Petition No. 1312
Responses to Interrogatories
Set Two
October 24, 2017

Project Schedule

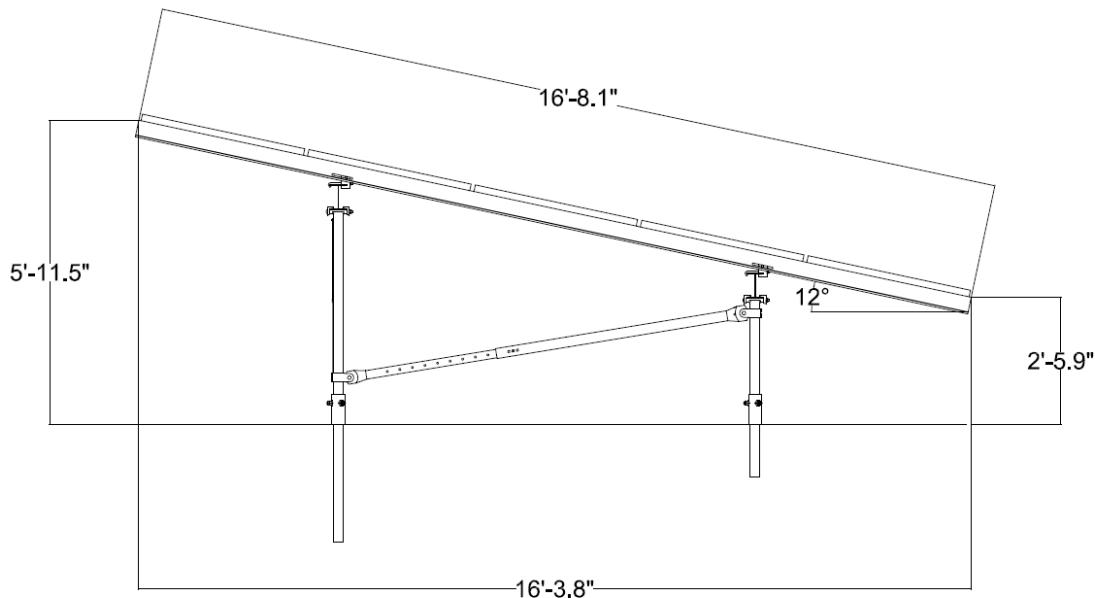
108. *Provide an end view drawing of the solar panels on a rack to show the 15 degree angle (or as applicable) and the edges of the solar panels along the hypotenuse of the triangle. Also include the heights to the top and bottom vertices of the hypotenuse above grade. (An example of such a drawing is Petition No. 1310, Sheet G-001, Solar Racking System Detail.) With the proposed panels using a “landscape” orientation and a width of 991 mm (39 inches or as applicable), how many panels would be placed along the hypotenuse of the triangle? (See JA Solar Specifications Sheet under Attachment 9 of the Petition.)*

Per the figure shown below, there will be 5 panels placed in landscape orientation along the hypotenuse of the triangle.
